## TECHINICAL BULLETIN

Rivet Type vs. New NVR Technology

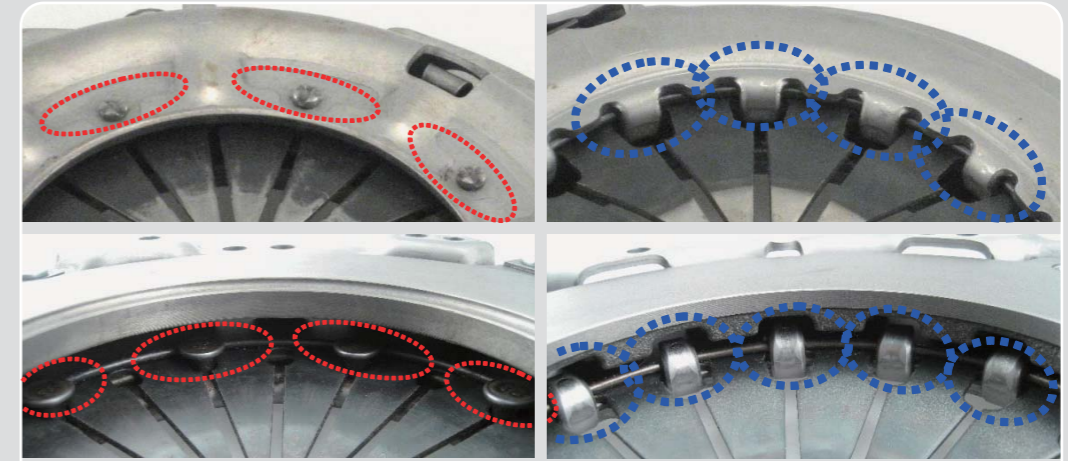
AISIN is converting the older Rivet Type Clutch Cover into the newest Noise Vibration Reduction Type (NVR) Technology. Since the Original Equipment Clutch Systems that AISIN supplies for the Automotive Manufacturers are being converted to the new technology, AISIN Aftermarket is following their lead. Although they may look physically different, it is just an illusion. The NVR Cover fitment is identical to the older Rivet Type, except with technological improvements in function, durability and driveability.

Rivet Type vs. New NVR Technology

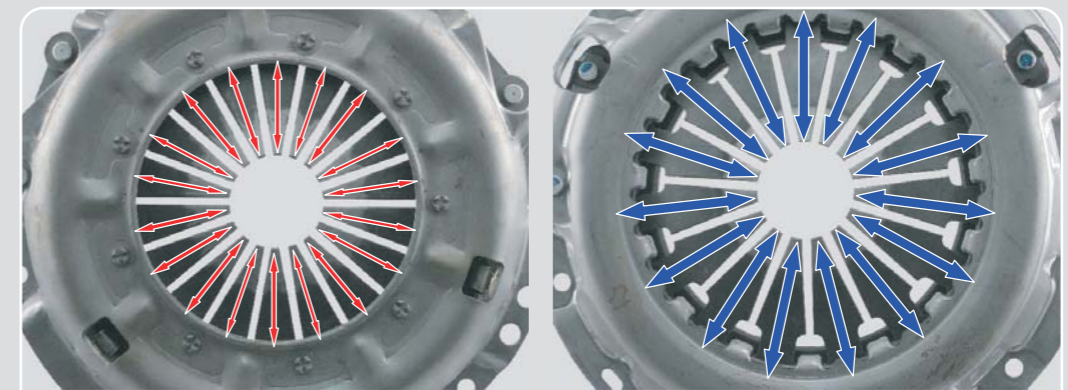
NVR Technology enables stronger spring support, resulting in better clutch control.

NVR Covers have fewer Fingers, but the Diaphragm Spring Fingers are thicker and stronger .

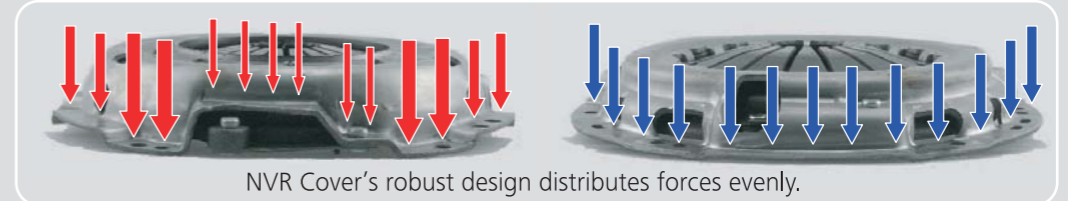
Straps and Levers are enclosed, increasing the cover rigidity.

NVR Cover's robust design distributes forces evenly.
